Original Job: QU02697_RESERVE_BLDG F1_REFRESHED_11252024 - 1224831

Job: QU02697_RESERVE_BLDG F1_REFRESHED_11252024 - 1243065
F03, QU02697_RESERVE_BLDG F1_REFRESHED_11252024

F03

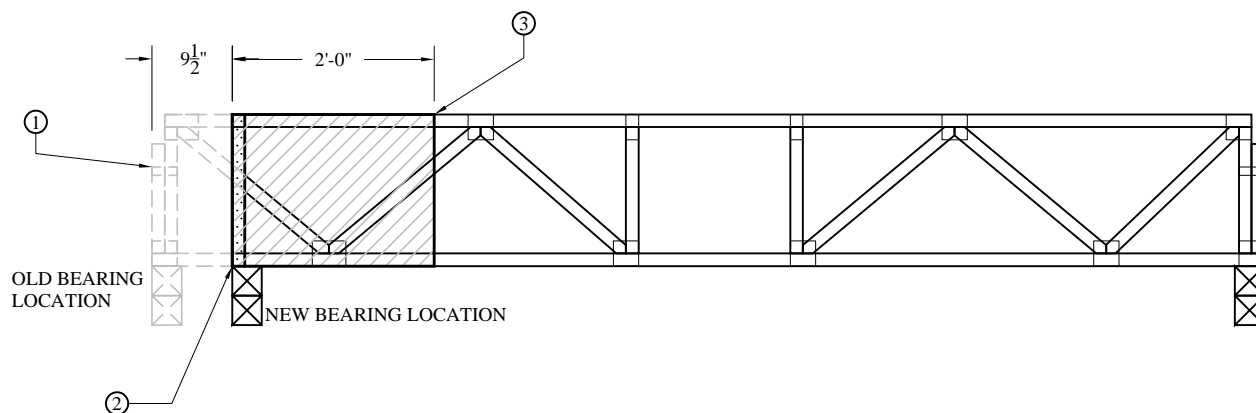
PROBLEM:

TRUSS STUBBED BACK 9.5" FROM THE LEFT END

SOLUTION:

1. REMOVE PORTION OF TRUSS AS SHOWN.
2. INSERT NEW 4 x 2 SYP-#1 MEMBER IN PLANE AS SHOWN, CUT AND FIT TIGHTLY.
3. ATTACH (2) 3/4" OSB TO TRUSS WITH (1) STAGGERED ROW OF (.131 x 3") COMMON NAILS, OR EQUIVALENT, AT 4" O.C. TO EVERY CONTACT MEMBER; STAGGER ROWS ON OPPOSING SIDES, ONE EACH SIDE.

1. FULLY SUPPORT TRUSS AND FLOOR/ROOF STRUCTURE BEFORE CUTTING AND REMOVING NECESSARY WEBS AND CHORDS AND ADDING NEW MEMBERS IN-PLANE TO ACHIEVE NEW TRUSS CONFIGURATION.
2. ONLY AFTER REPAIR HAS BEEN INSTALLED PROPERLY SHALL TEMPORARY SUPPORTS BE REMOVED.
